Sunrise Ranch West Unit 2 Revisited CPN 675782

September 2019- Curtis Cherne, DRC

**Re: Sunrise Ranch West Subdivision
Analysis for 106th St SW
Drainage Report, Engineer's Stamp Date 3-24-2015 (File: L08D14)**

Re: SUNRISE WEST RANCH SUBDIVISION 106TH STREET CAPACITY

Manning Formula:

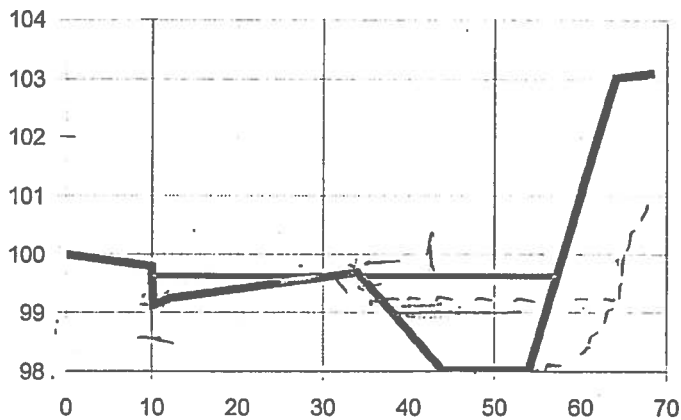
- Provide a plan view of the stub out improvement, reflecting the slope of 0.0057 used to calculate the flow.
- Original storm drain design captured flows from the west. With the grated manhole closed all flows from the west will be carried in the channel. Channel should be widened for this additional capacity allowing 1 foot of free board.

manning

note pre and post
